# Access Compliance Report

## Public Rights-of-Way

Intersection ID: 9440	Main Street: BRADFORD_DR	Cross Street: EDGEWOOD_RD	Location: S
ADA ID: BC44F6FFE74E	Ramp Type: Perp	Initial Pass/Fail: Fail	Overall Compliance: No
Codes/Mitigation Info/Possible Solution		Field Measurements/Component Compliance	
Severity Score: 13.75

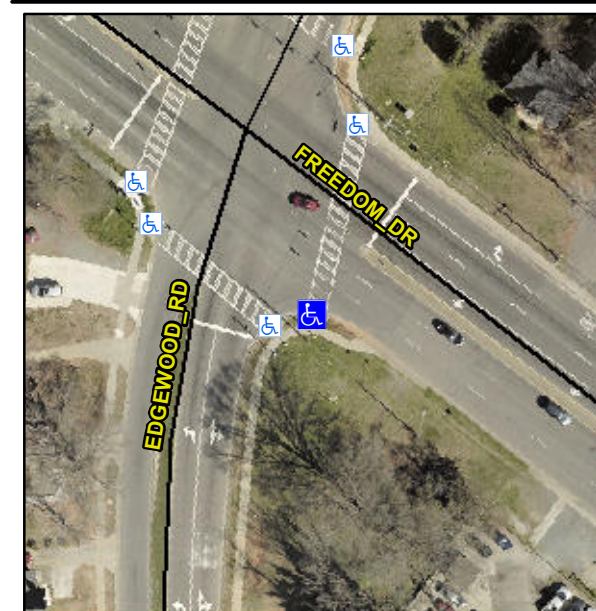
**Not Found, R304.2.2**

Compliance	Description	Data	Compliance	Description	Data
N/A	Ramp Length (in)	60.0	No	Ramp Slope (%)	8.4
Yes	Ramp Width (in)	48.0	Yes	Ramp XSlope (%)	3.6
N/A	Flare Type LT	N/A	N/A	Flare Type RT	N/A
N/A	Flare Slope LT (%)	N/A	N/A	Flare Slope RT (%)	N/A
N/A	Flare Traversable LT?	N/A	N/A	Flare Traversable RT?	N/A
N/A	Landing Length (in)	N/A	N/A	DWS Provided?	N/A
N/A	Landing Width (in)	N/A	N/A	DWS Contrast?	N/A
N/A	Landing Slope (%)	N/A	N/A	DWS Length (in)	N/A
N/A	Landing X Slope (%)	N/A	N/A	DWS Full Width?	N/A
N/A	Landing Curb? (Y/N)	N/A	N/A	DWS Offset (in)	N/A
N/A	Shared Landing?	N/A			
N/A	Gutter Ponding?	N/A	N/A	Gutter Slope (%)	N/A
N/A	Gutter Lip Ht (in)	N/A	N/A	Gutter X Slope (%)	N/A
N/A	Painted X Walk1?	Yes	N/A	Painted X Walk2?	N/A
	X Walk 1 Direction	To NE		X Walk 2 Direction	N/A
N/A	X Walk 1 Width (in)	113.0	N/A	X Walk 2 Width (in)	N/A
	X Walk 1 Slope (%)	3.7		X Walk 2 Slope (%)	N/A
	X Walk 1 X Slope (%)	3.7		X Walk 2 X Slope (%)	N/A

**Remove & Replace Entire Ramp.**
